**ENGINEERING DIRECTIVE**

**REVISIONS TO THE CONSTRUCTION STANDARD DRAWINGS ON  
PRECAST MEDIAN BARRIER FOR TEMPORARY TRAFFIC CONTROL**

The purpose of this Engineering Directive is to formally notify **ALL** Department Engineering Personnel of a change to the Construction Standard Drawings 40I.15.1 and 40I.15.2.

DATE OF ISSUE  
NOVEMBER 1994  
DRAWING NUMBER  
401.15.1

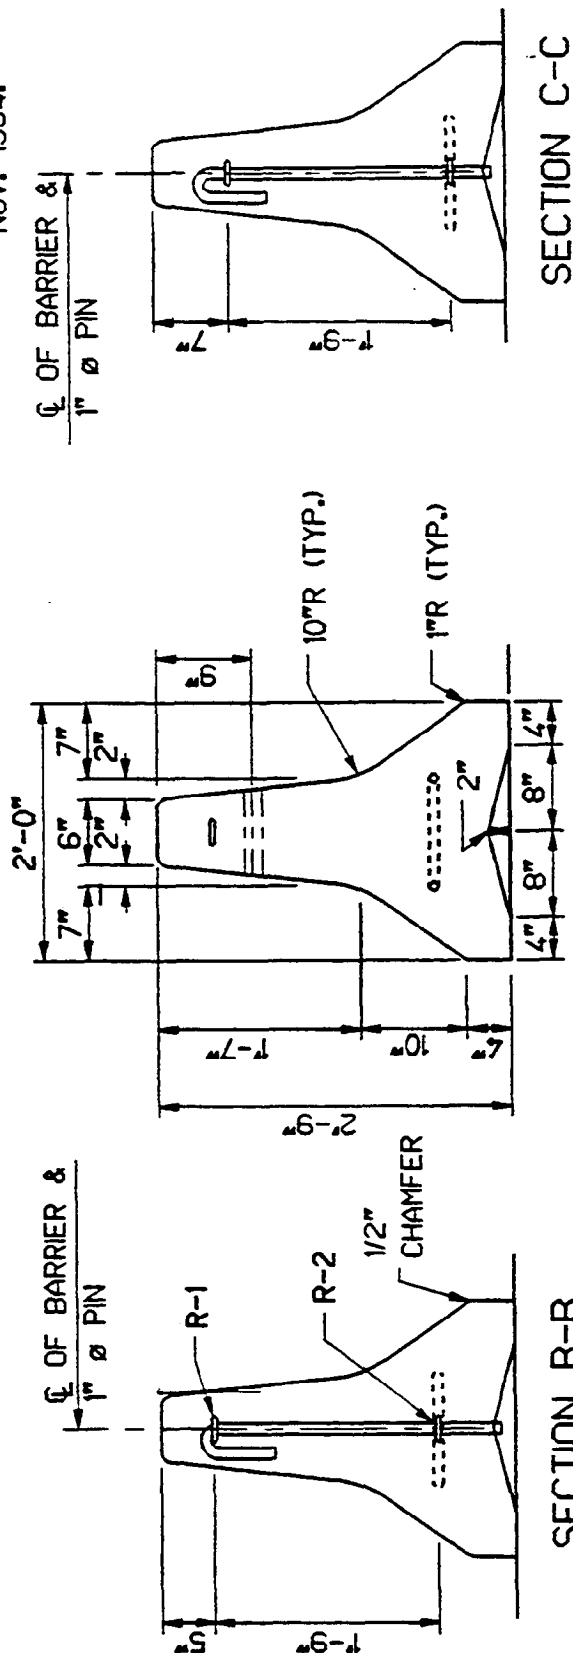
Effective immediately, in all projects, the connecting pin is to be completely contained within the cross section of the barrier. Notes on Drawing 40I.15.1 require the pin to be heat bent to ensure a smooth bend and prevent shattering of the pin.

NOTE:  
THE ENTIRE PIN JOINING ADJACENT BARRIERS MUST BE COMPLETELY  
WITHIN THE CROSS-SECTION OF THE TEMPORARY CONCRETE BARRIER.

CONNECTION PIN DETAIL

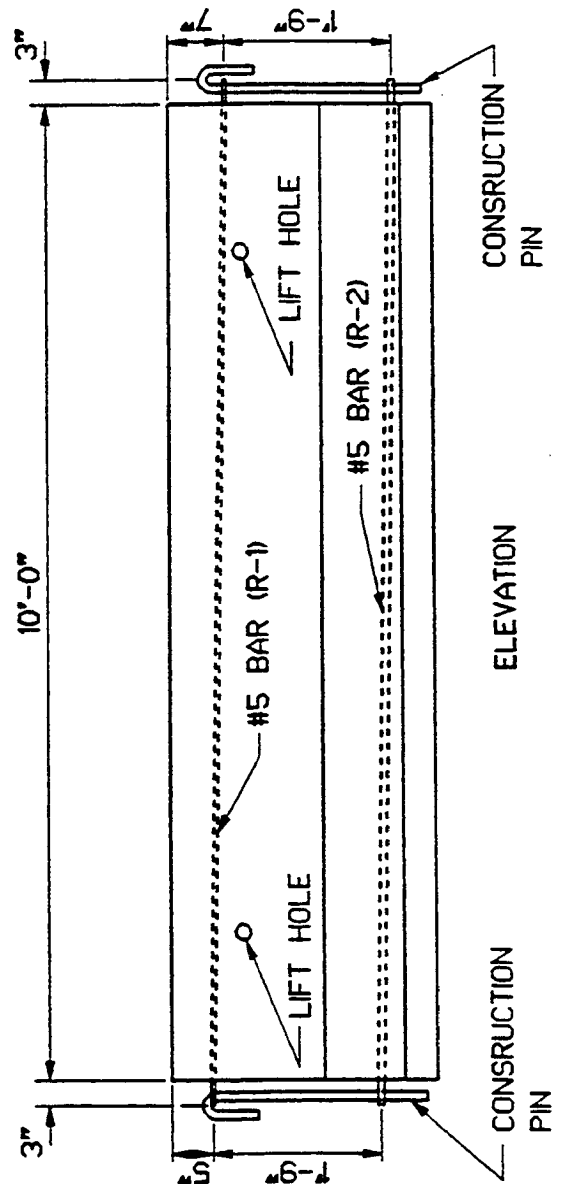
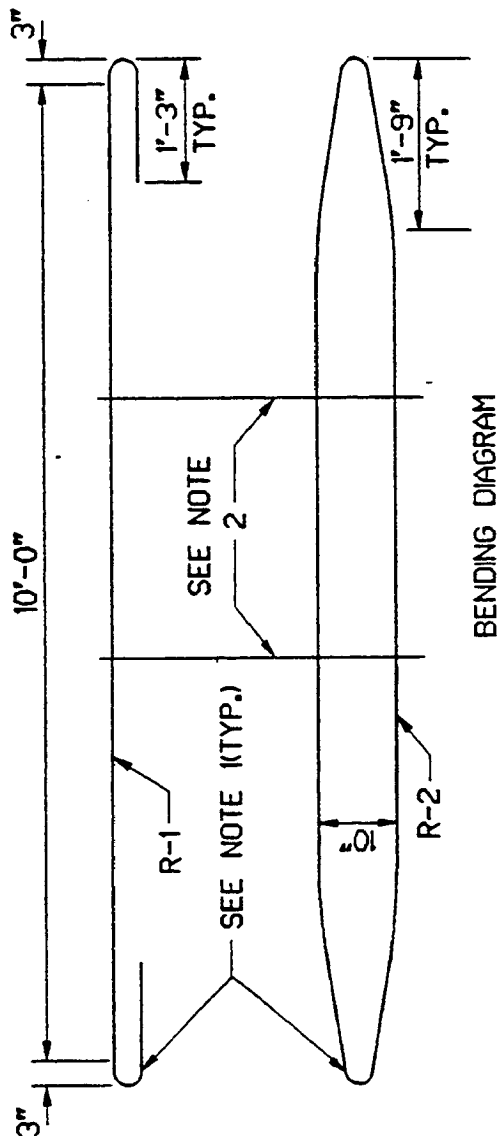
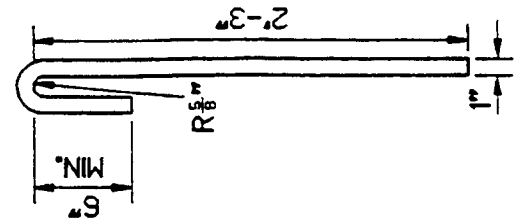
1. BEND REBARS AROUND A 1 3/8"  $\phi$  ROD.
2. BARS R-1 AND R-2 SHALL BE FABRICATED CONTINUOUSLY, OR AT THE OPTION OF THE CONTRACTOR, THE BARS MAY BE FABRICATED WITH 15" MINIMUM LAPS AT THE LOCATIONS SHOWN.
3. PIN CONNECTION SHALL BE COMPLETELY WITHIN THE CROSS-SECTION OF THE BARRIER.
4. THE 1"  $\phi$  PIN SHALL BE HEAT BENT TO A 5/8" RADIUS (1 1/4" DIAMETER).
